Bush Terminal Piers Park

NYC Public Design Commission
Final Review
August 14, 2023

Bush Terminal Piers Park | Phase 2 - Picnic Area Enlargement Plan

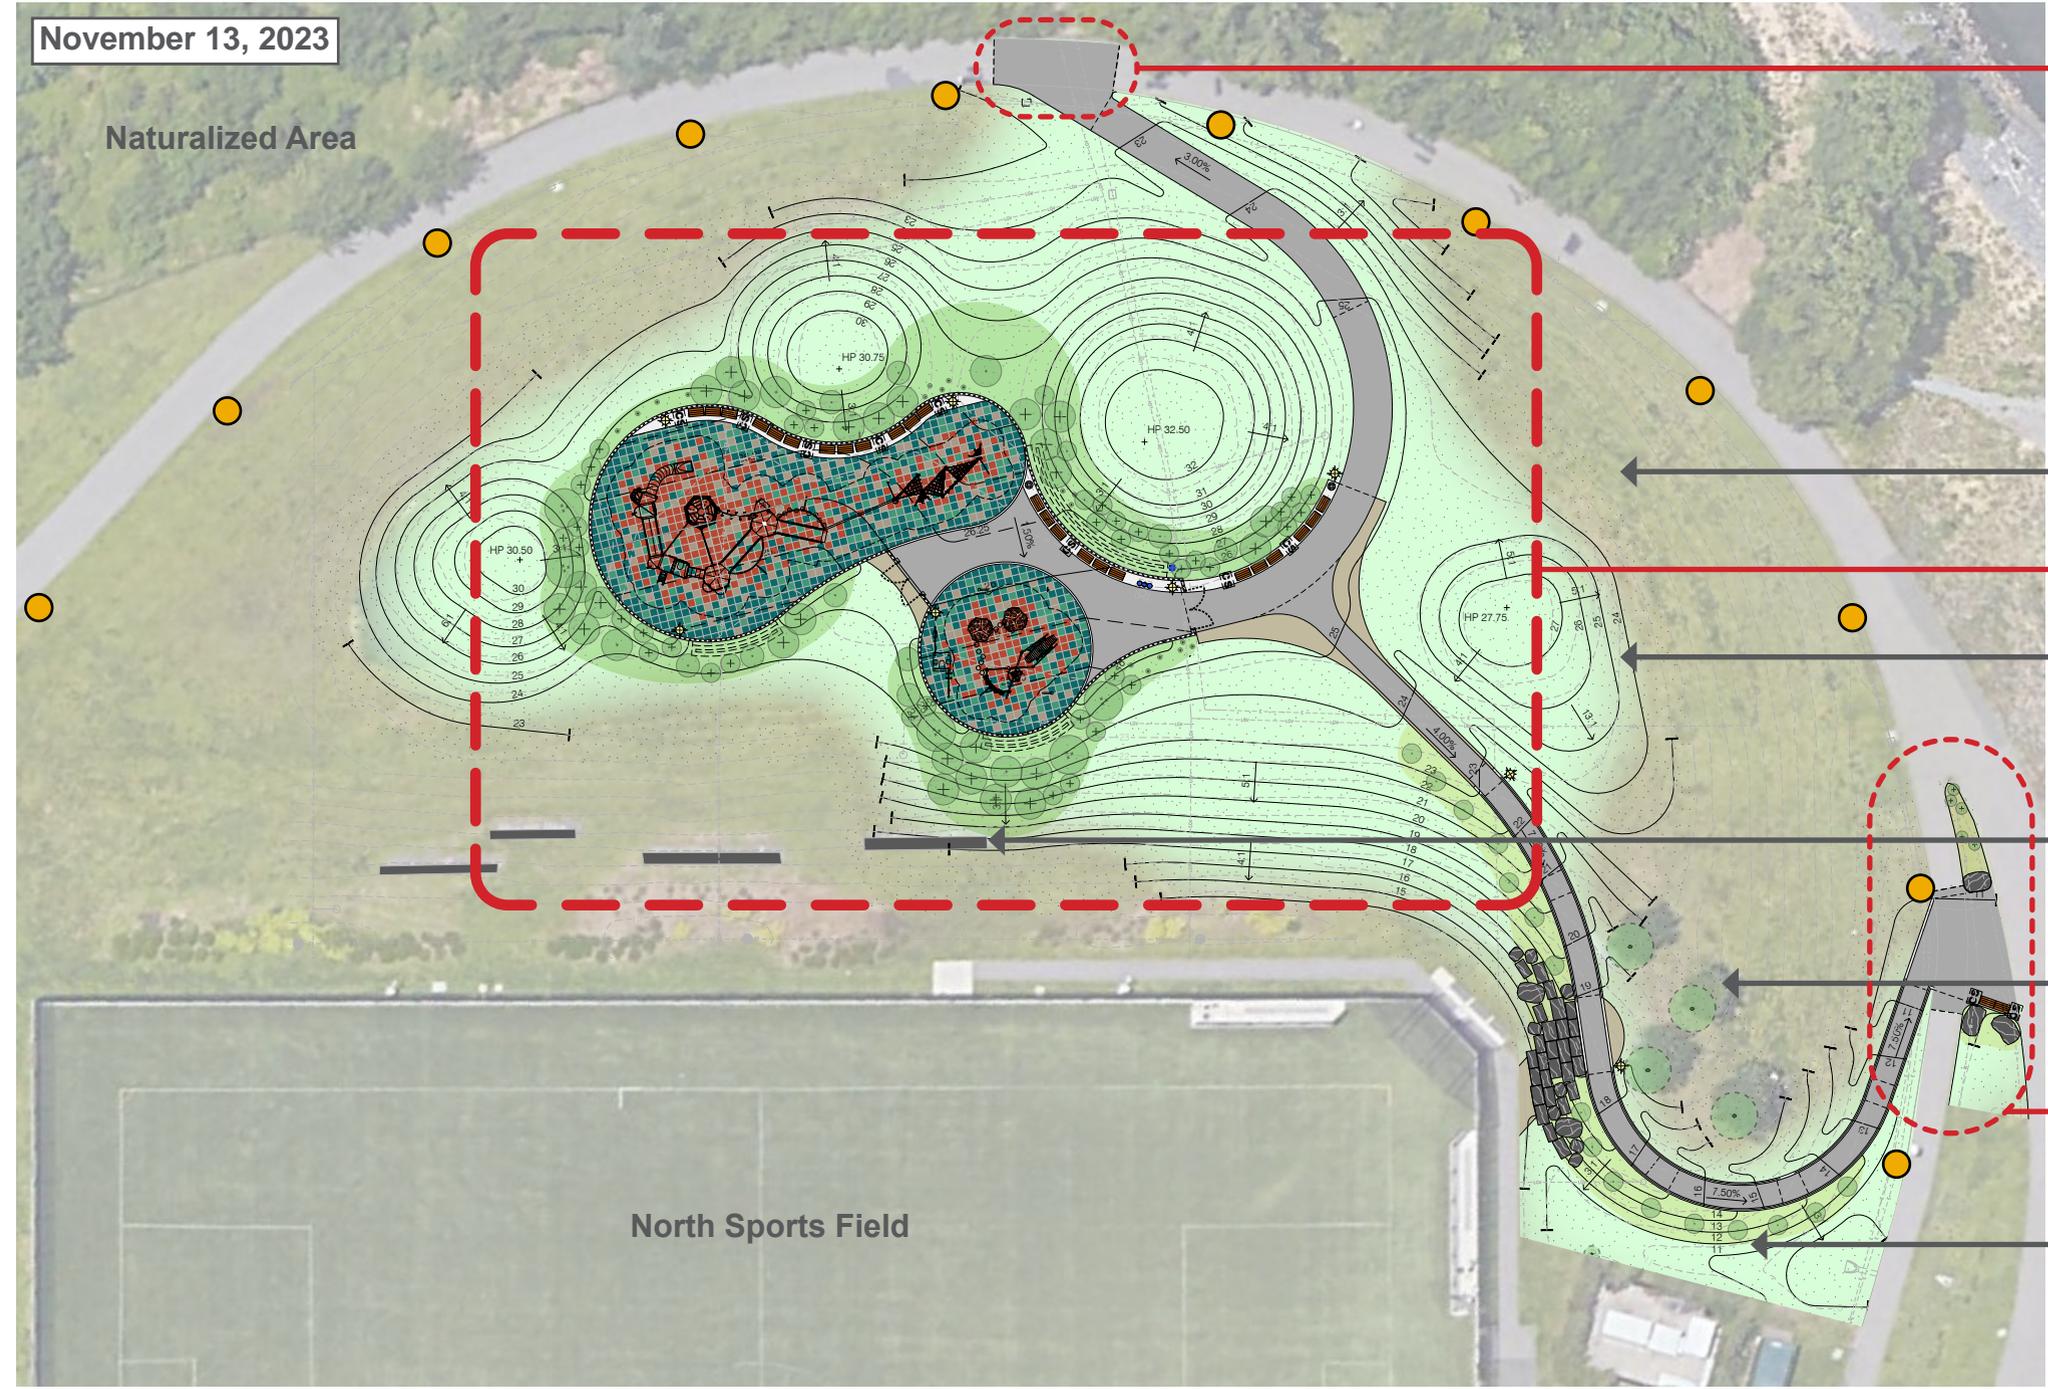
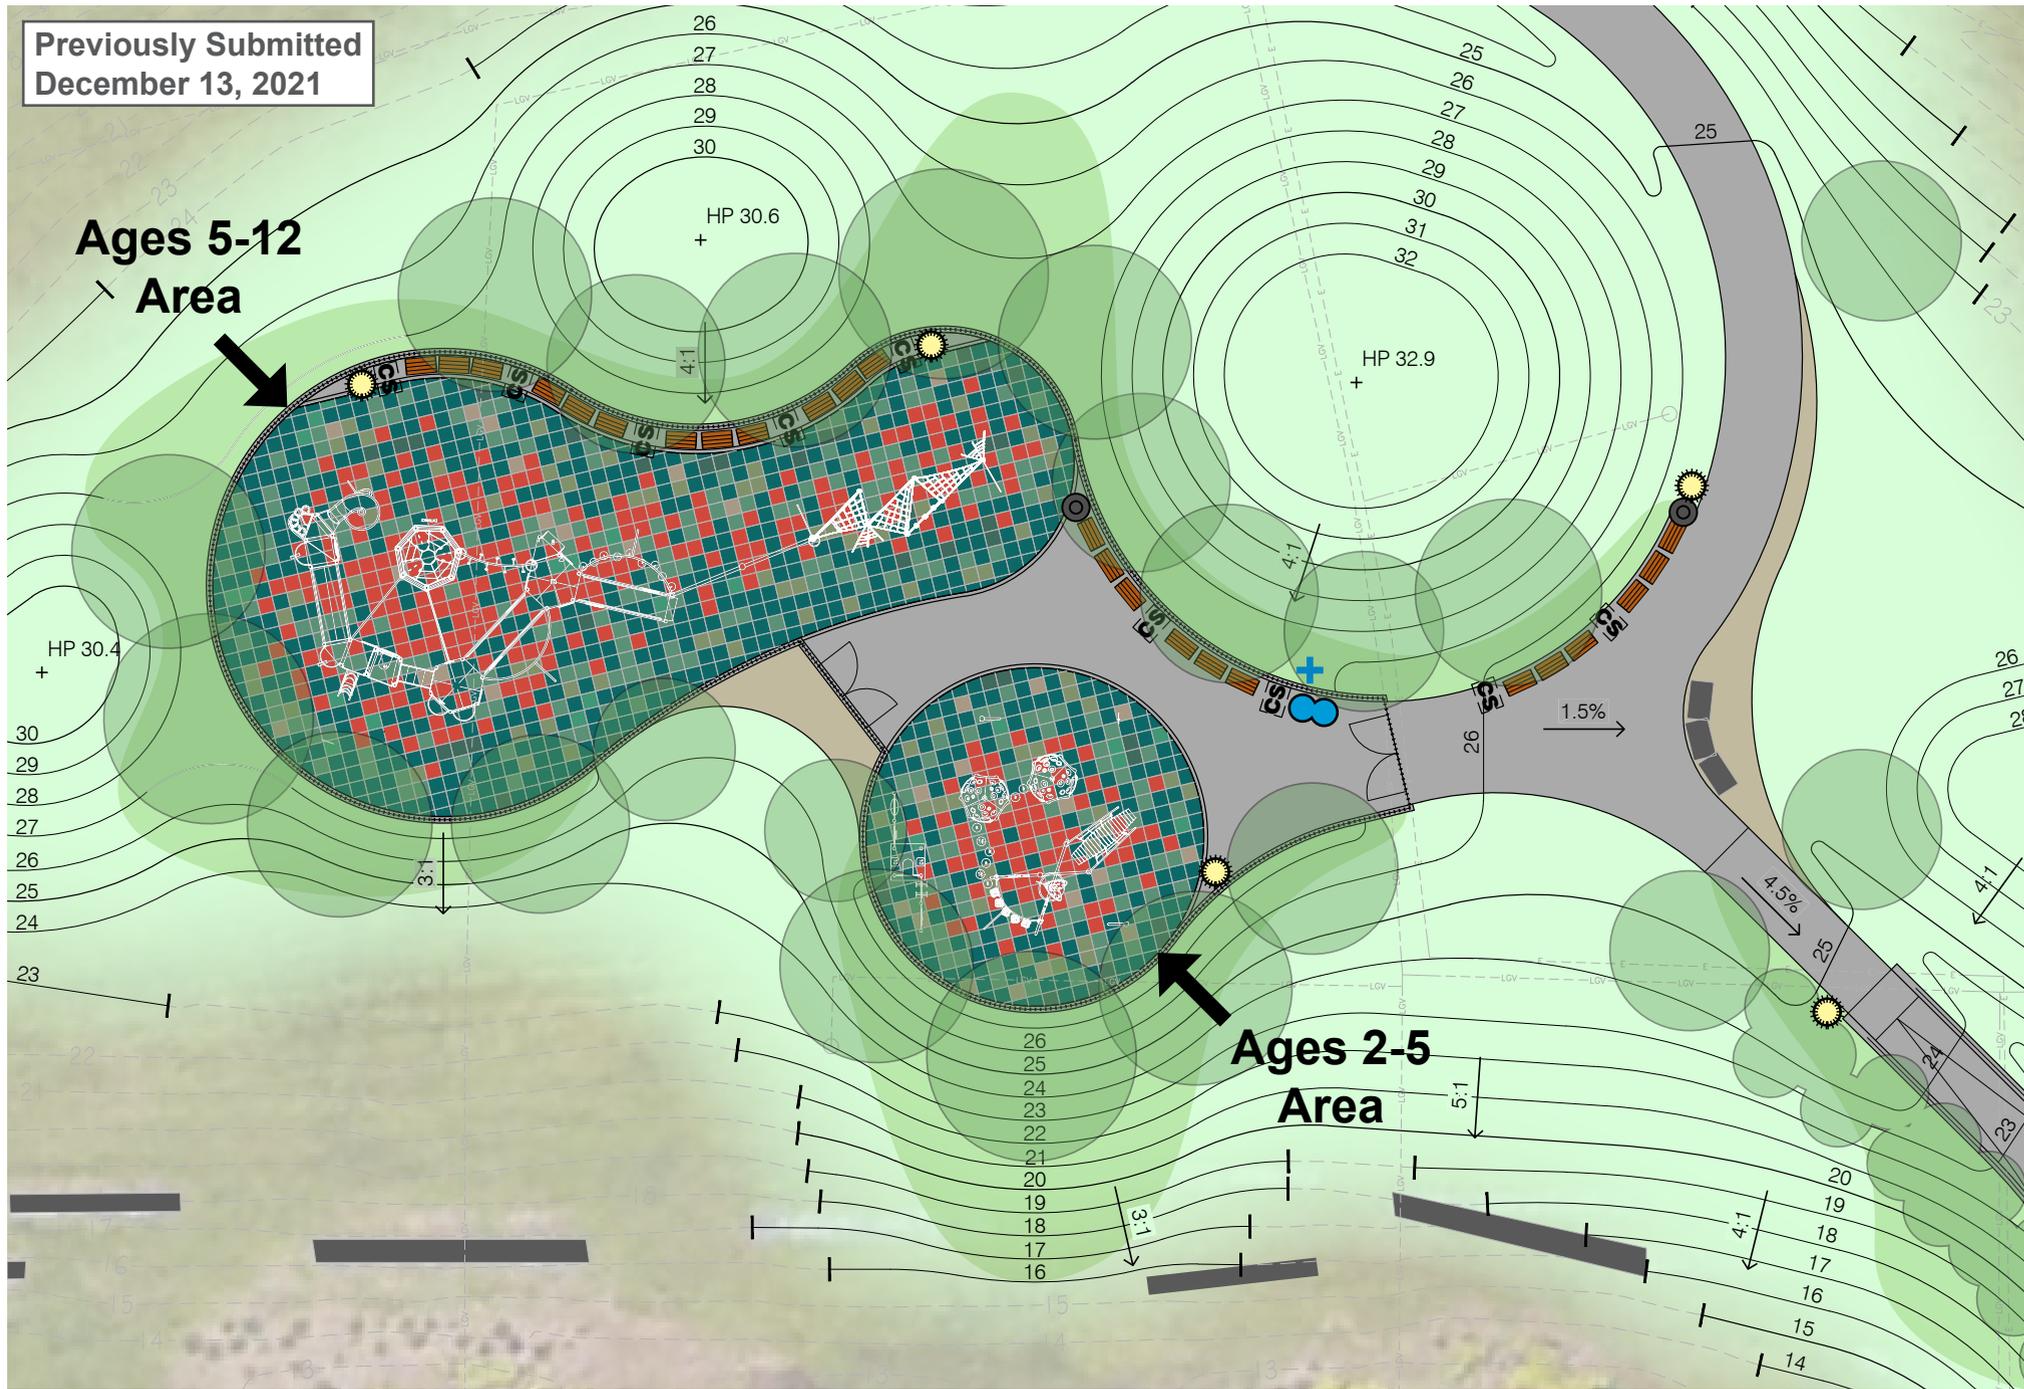
Limit of Work Revision

Play Area Revisions

Limit of Work Revision Stone Slabs Added, Typ.

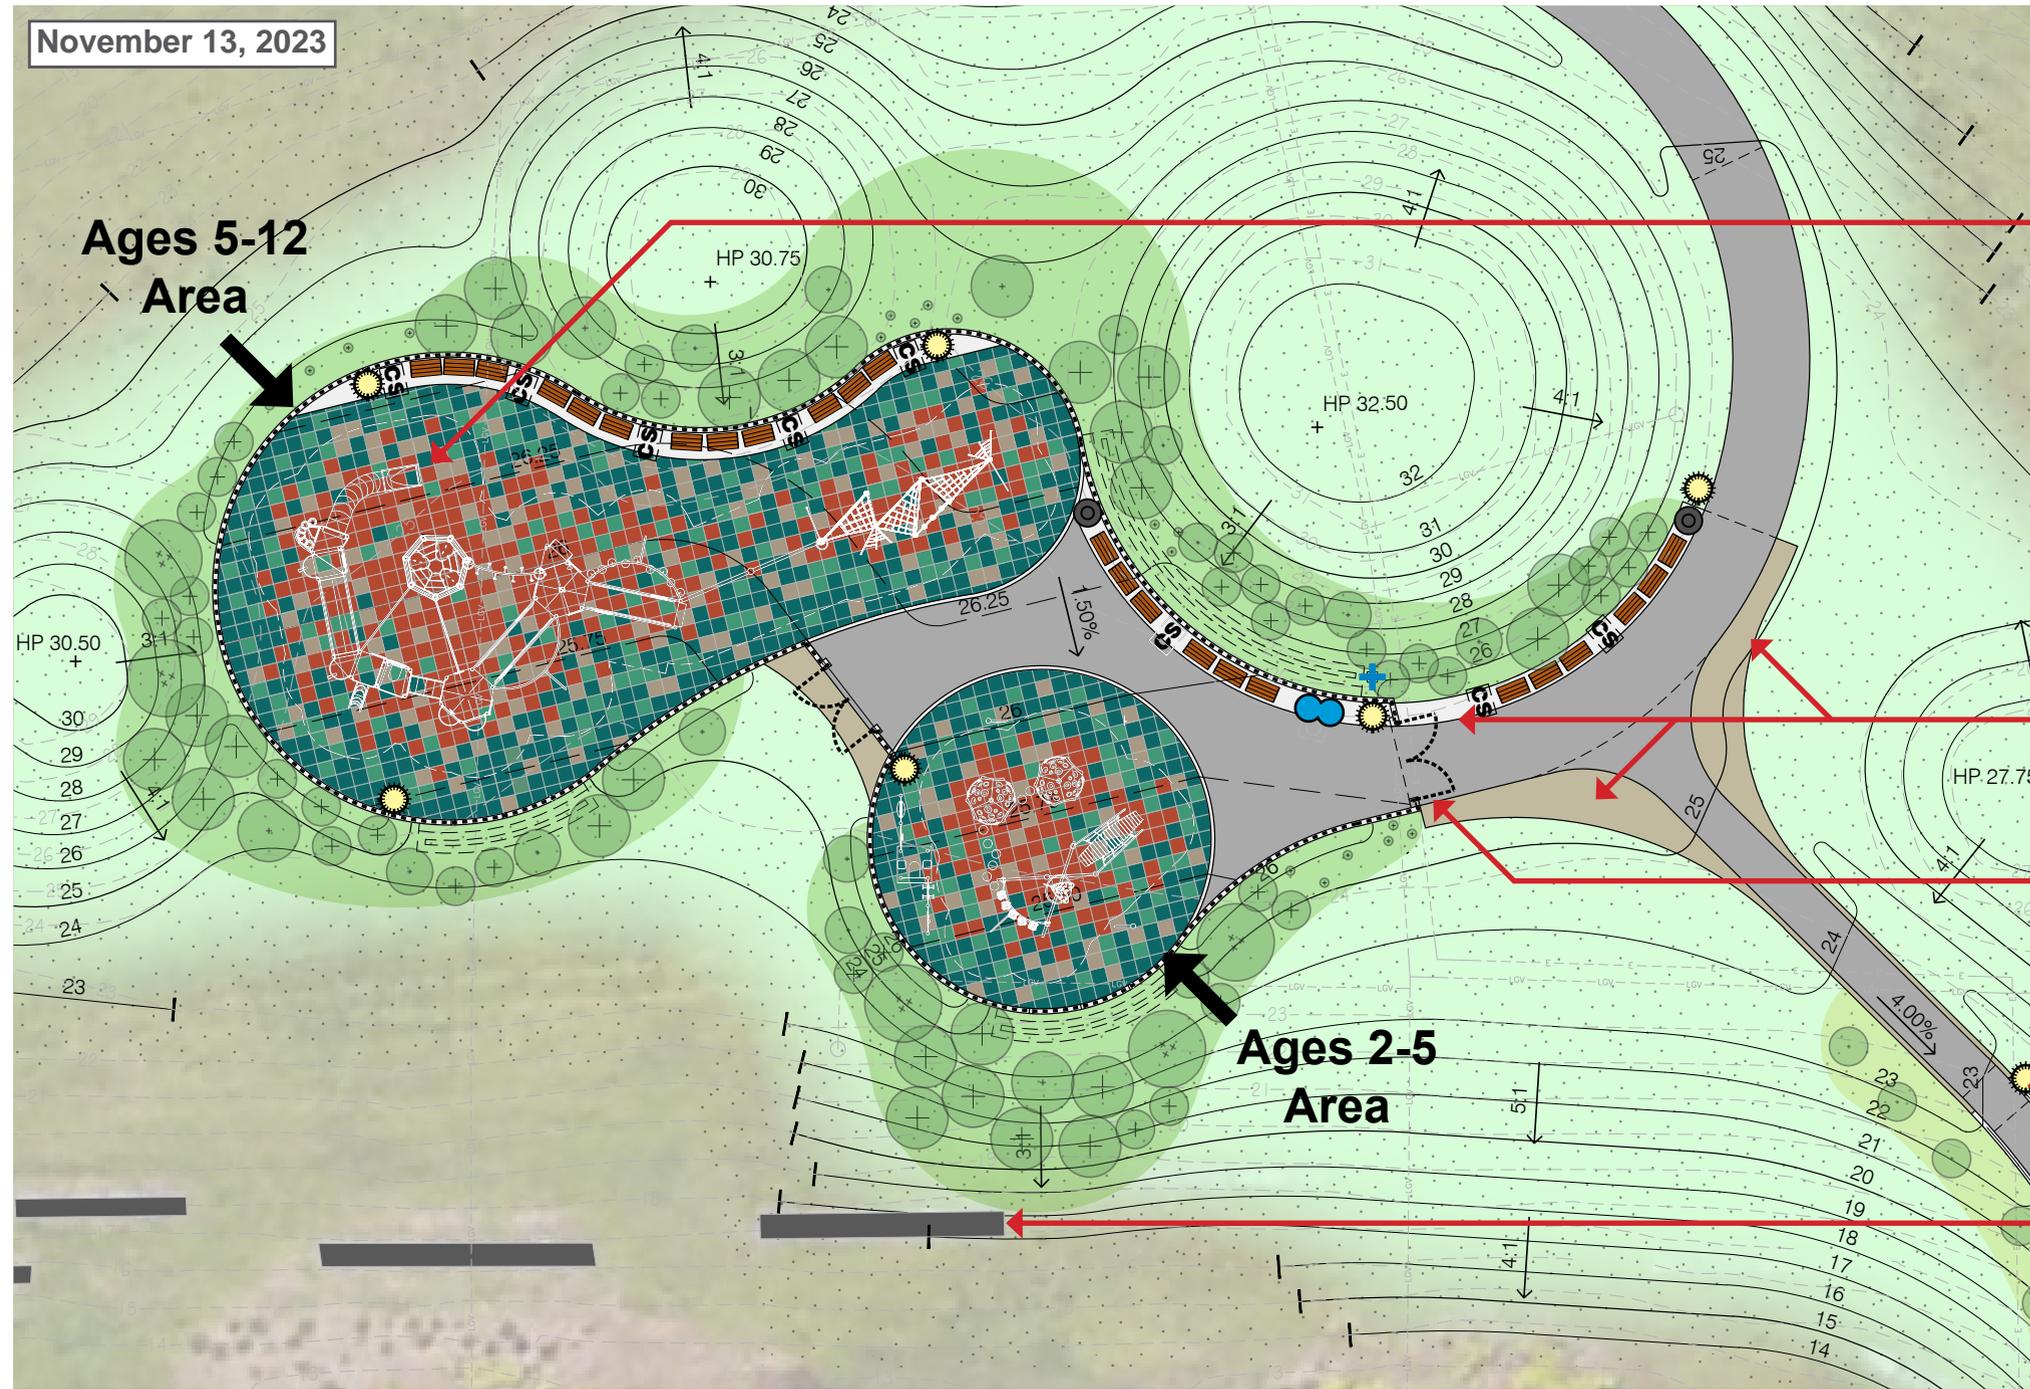
Slide Design Updated Per DPR

Paving Material + Layout Refined

Gate Swings Updated Per DPR, Typ.

Light Poles Added + Relocated Per DOT, Typ.

Stone Slab Layout Refined

Bush Terminal Piers Park | Relocated South Park Entrance - Proposed Plan

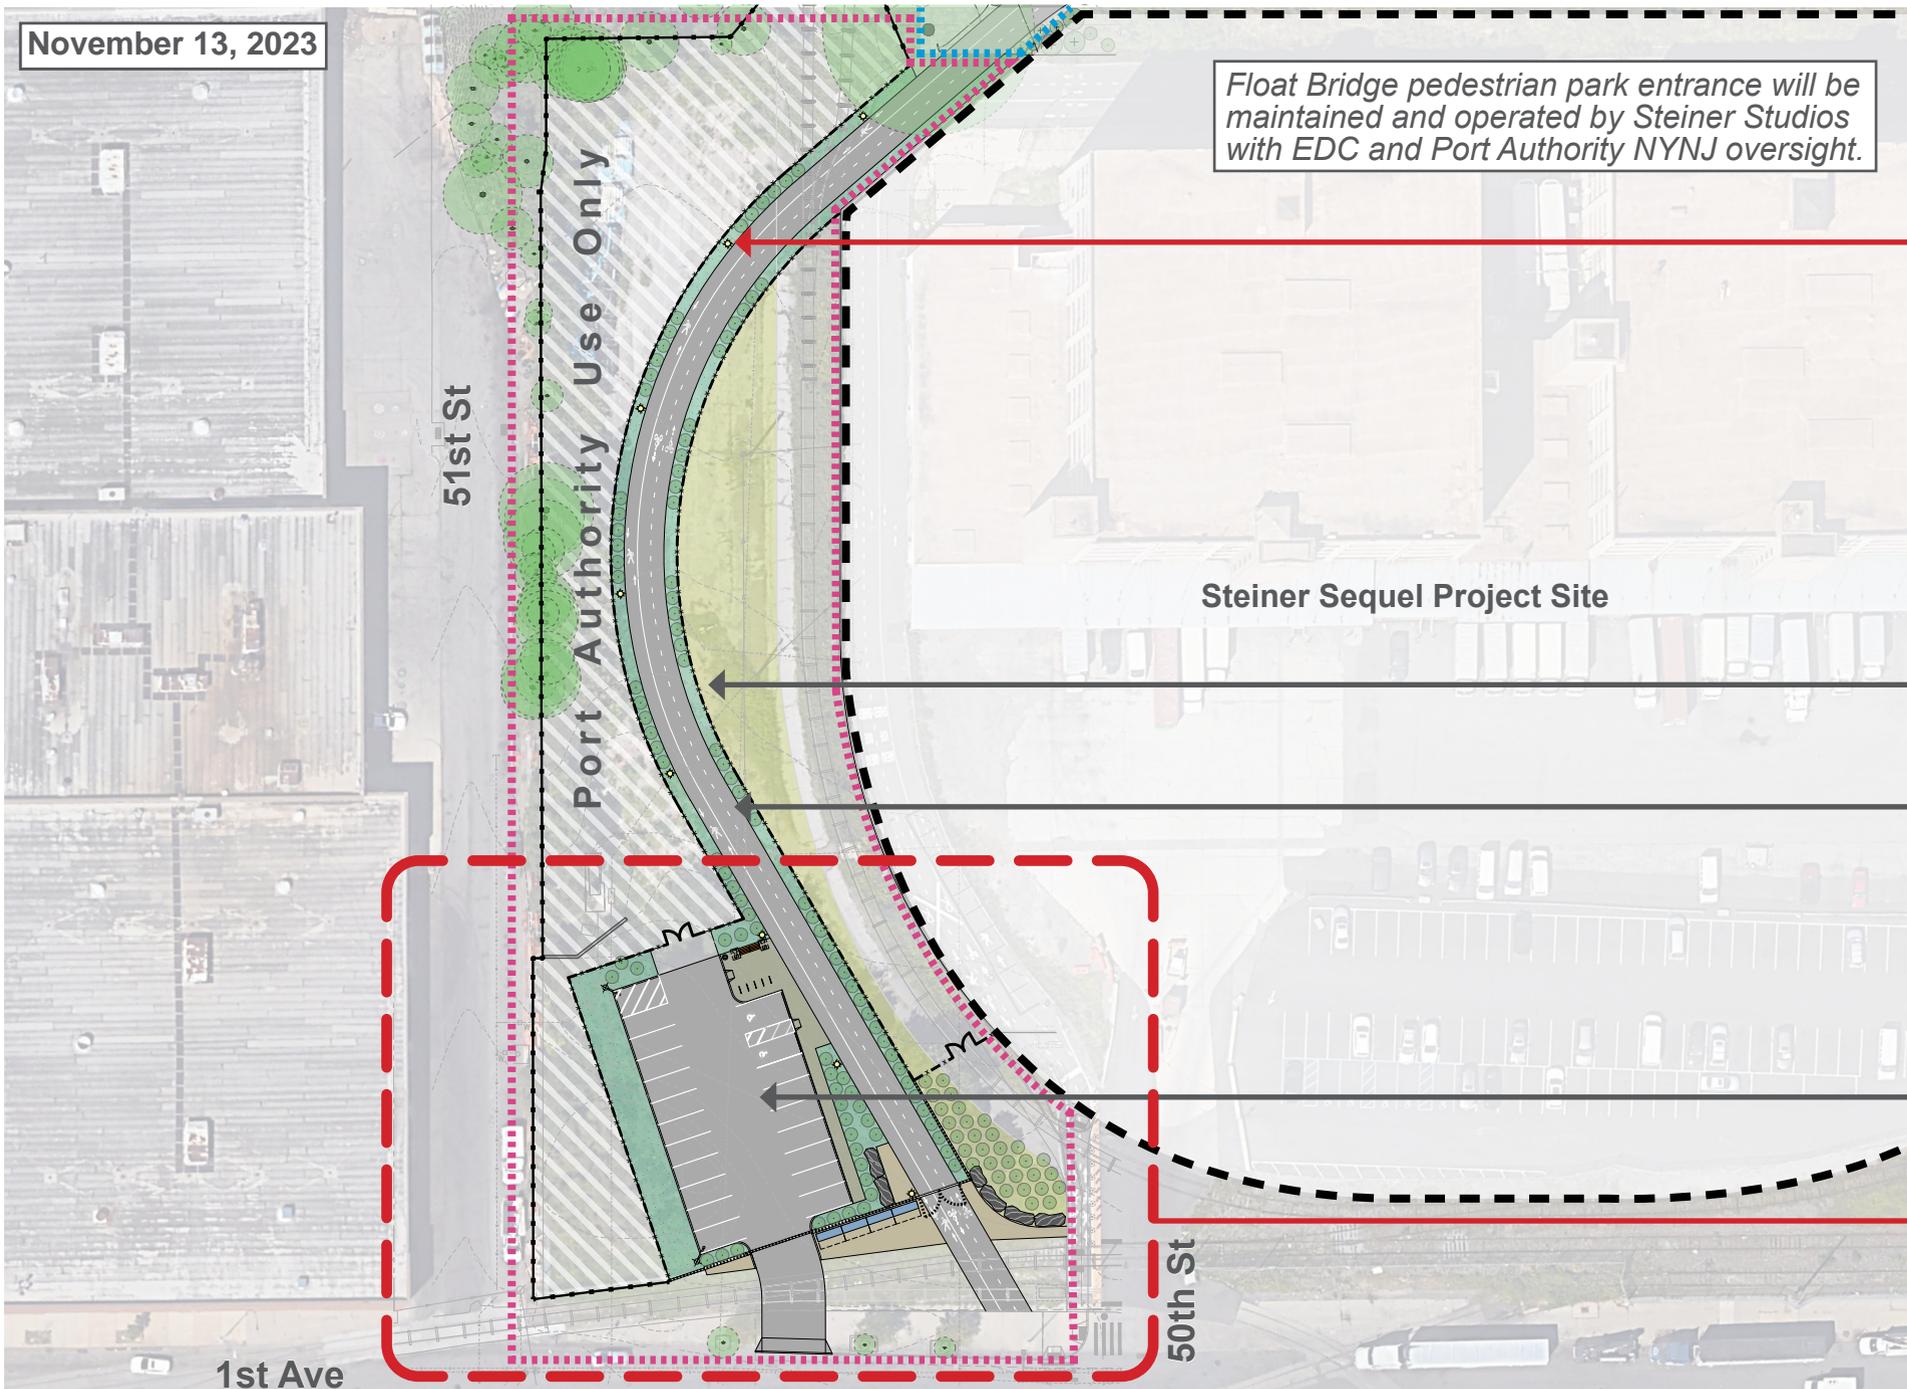
Light Poles Added + Relocated Per DOT, Typ.

Entry Revisions
